ALLAMAKEE CSD MIDDLE SCHOOL HVAC UPGRADE
WAUKON, IOWA

ADDENDUM 03
March 11, 2026

Allamakee Community School District Waukon Middle School HVAC Upgrade

ADDENDUM NUMBER 3

M-111B

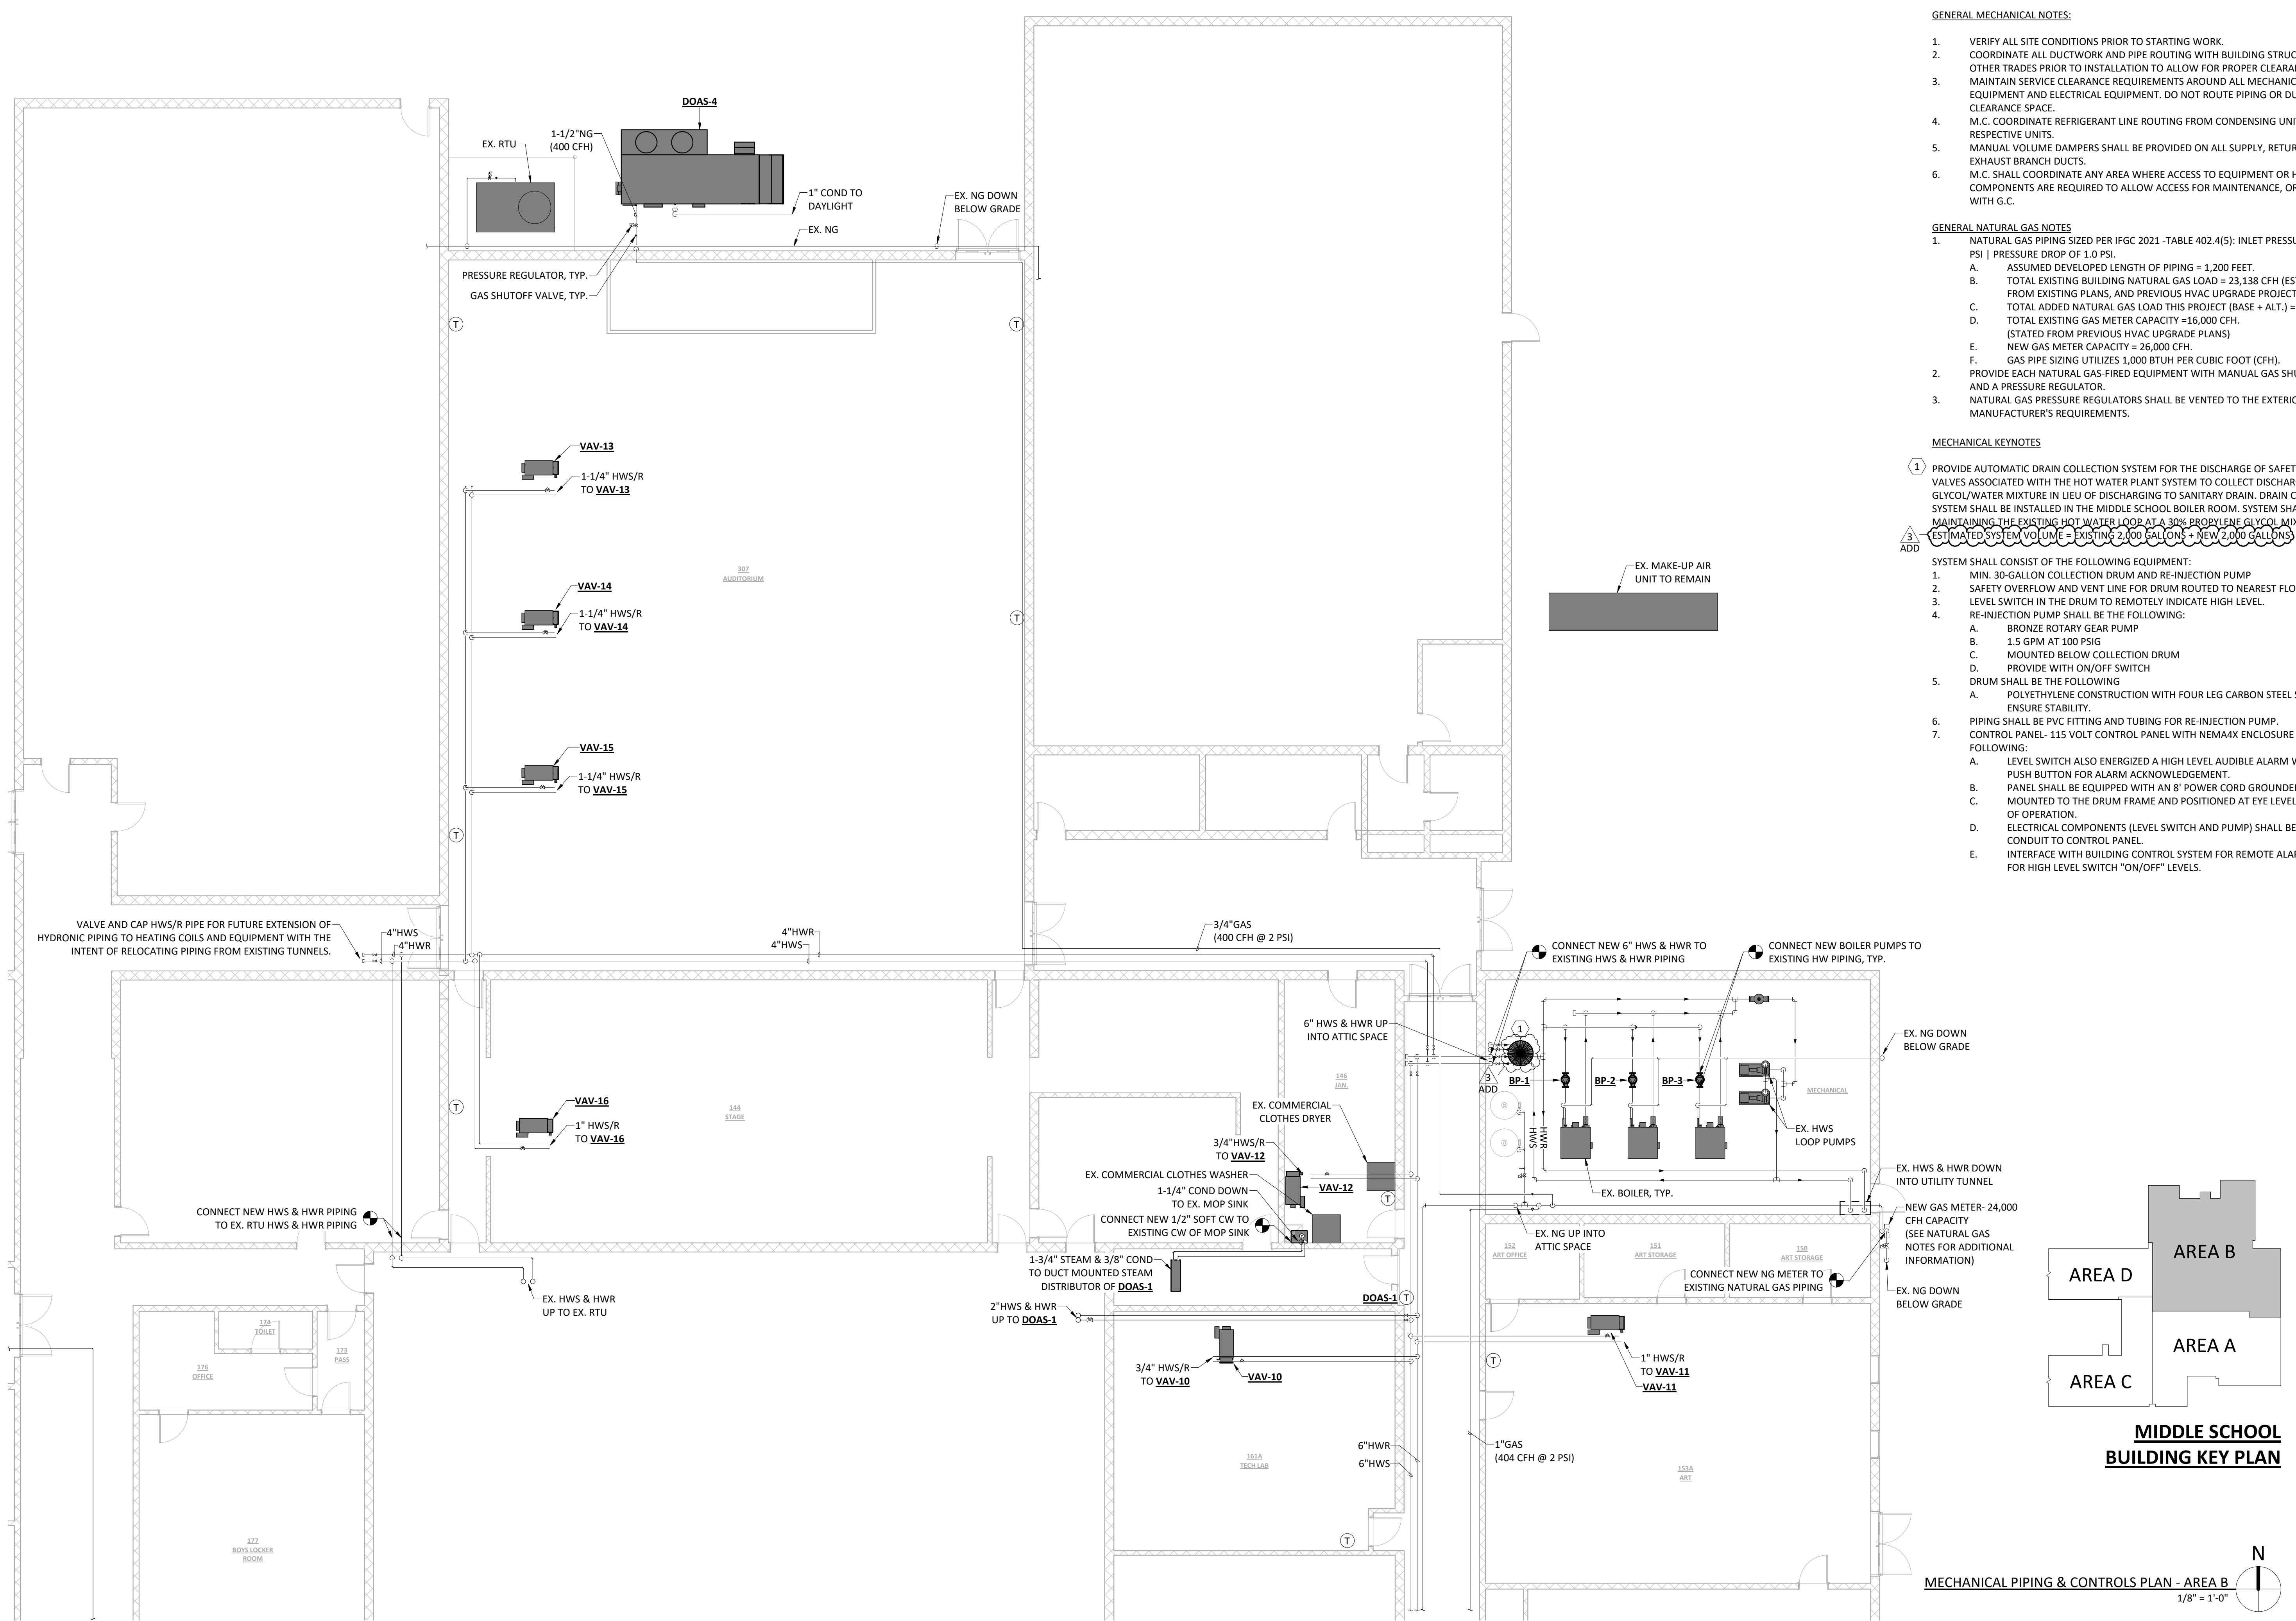
- M3-2 Drawing **M-111B – MECHANICAL PIPING & CONTROLS PLAN – AREA B**
1. Added estimated volume of hot water system for the existing and added piping.
 2. Added glycol collection system within mechanical room.

- PROVIDE AUTOMATIC DRAIN COLLECTION SYSTEM FOR THE DISCHARGE OF SAFETY RELIEF VALVES ASSOCIATED WITH THE HOT WATER PLANT SYSTEM TO COLLECT DISCHARGED GLYCOL/WATER MIXTURE IN LIEU OF DISCHARGING TO SANITARY DRAIN. DRAIN COLLECTION SYSTEM SHALL BE INSTALLED IN THE MIDDLE SCHOOL BOILER ROOM. SYSTEM SHALL ASSIST MAINTAINING THE EXISTING HOT WATER LOOP AT A 30% PROPYLENE GLYCOL MIXTURE. (ESTIMATED SYSTEM VOLUME = EXISTING 2,000 GALLONS + NEW 2,000 GALLONS)

M-604

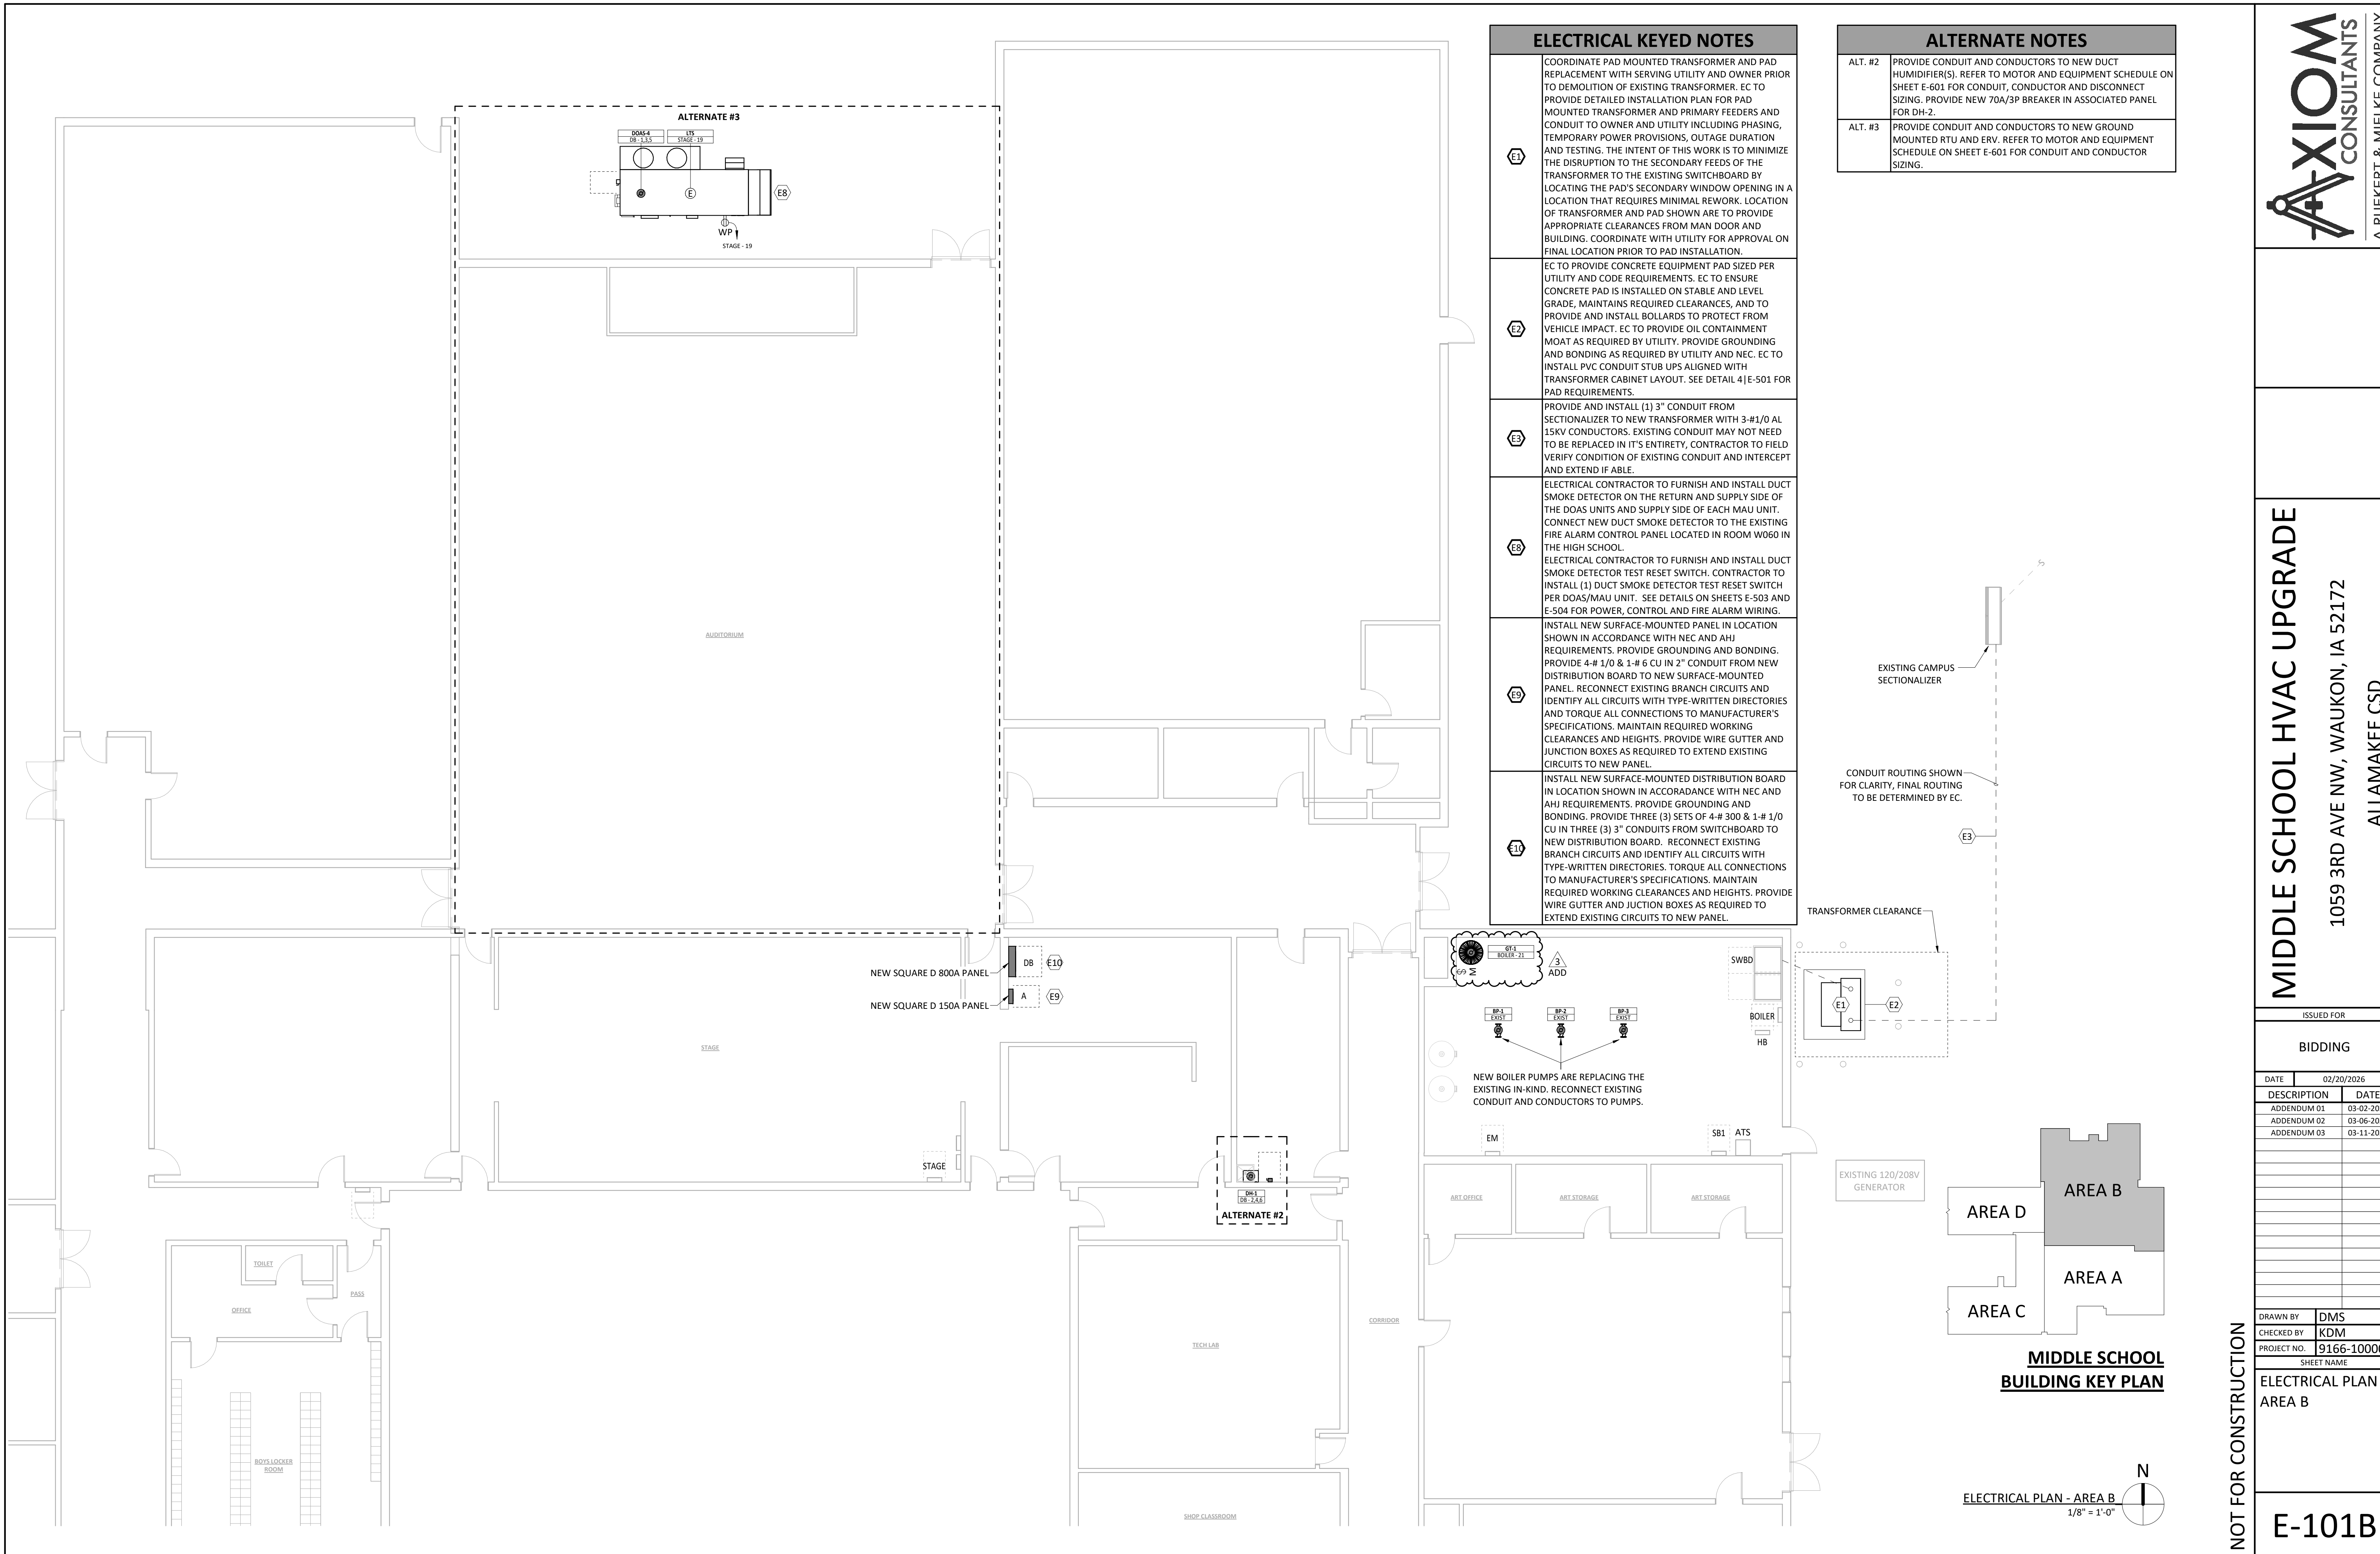
- M3-4 Drawing **M-604 – MECHANICAL SCHEDULES**
1. Added glycol collection schedule.
- E3-1 Drawing **E-101B – ELECTRICAL PLAN – AREA B**
1. Added and tagged direct connection symbol for glycol tank in mechanical room.

GLYCOL COLLECTION SYSTEM SCHEDULE												
PLAN MARK	LOCATION	SYSTEM	TANK SIZE (HEIGHT X Ø)	TANK VOLUME	MAX. WORKING PRESSURE	FILL FLOW (GPM)	PRV (PSI)	ELECTRICAL			MANUFACTURER MODEL	NOTES
								HP	VOLTAGE	Ø		
GT-1	MECHANICAL ROOM	HEATING HOT WATER	42" X 28"	50 GAL	70 PSI	1.8	15	1/3	120	1	WESSELS 13050	ALL
1. PROVIDE 30% PROPYLENE GLYCOL MAKE-UP WATER SYSTEM WITH LOW-LEVEL ALARM AND CONTROLLER, PRESSURIZED TANK, CHECK VALVE, PRV FILL VALVE, ISOLATION VALVES, PRESSURE GAUGES, GLYCOL MIXING TANK, PROVIDE WITH CORD AND PLUG AND FILL PUMP. 2. LOW-LEVEL ALARM TO BE MONITORED BY CONTROLS SYSTEM. COORDINATE CONNECTIONS WITH TEMPERATURE CONTROLS CONTRACTOR.
